**Microsemi Corporation**

**Customer Notification No: 098-50620-100**

**Field Service Bulletin (FSB)**

**Subject:** April 6, 2019 GPS Week Rollover Workarounds for XLi Time & Frequency Instruments with the 86-8013 GPS Receiver

*Figure 1: Use the SyncServer S650 to lock to GPS and feed high accuracy IRIG DCLS to the XLi as its timing reference. This solution has minimal impact on all systems interfacing to the XLi.*

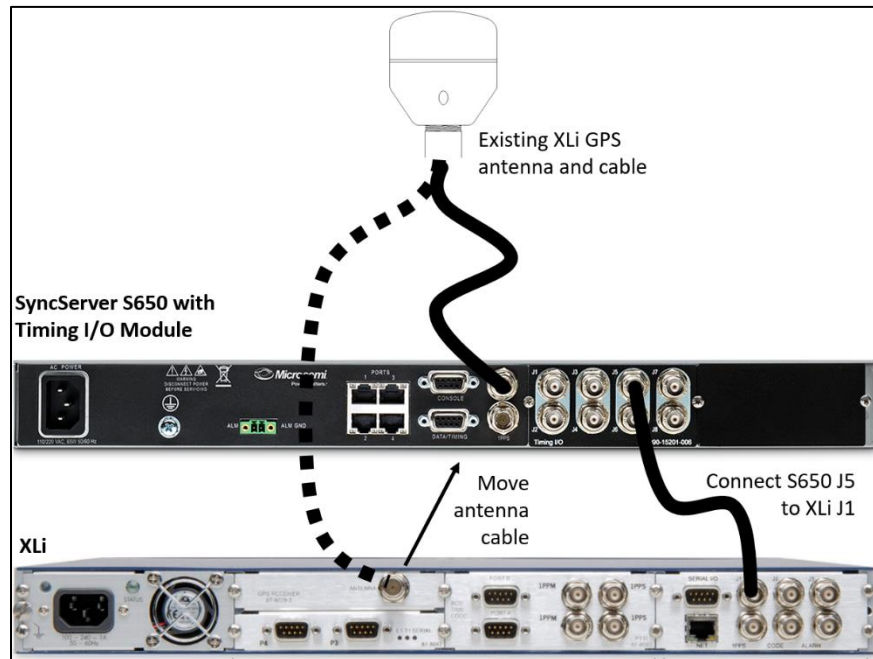
The best choice is to install a SyncServer S650 with a Timing I/O module between the XLi GPS antenna and the XLi as shown in Figure 1. The S650 will lock to GPS with <15ns RMS accuracy to UTC and provide an extremely accurate IRIG DCLS time code output as a high accuracy input to the XLi. This solution uses the same GPS antenna cable and GPS antenna as the XLi and is the easiest and least impactful solution. All of the systems and devices connected to and interfaced to the XLi will not be impacted and continue to operate as normal. See implementation details further below.

There are two ways to provide minimal disruption to the timing outputs of the XLi when adding the S650 as the source of time for the XLi. The best and least disruptive from a time accuracy standpoint is to use a splitter on the GPS antenna cable and connect both the XLi and the SyncServer S650 to the same antenna. This allows the S650 to lock to GPS and steer in the clock accuracy before becoming the source of time for the XLi. The other method will put the XLi in holdover while the S650 locks to GPS. Regardless, the ultimate objective is to have the S650 providing the time to the XLi as shown in Figure 1.
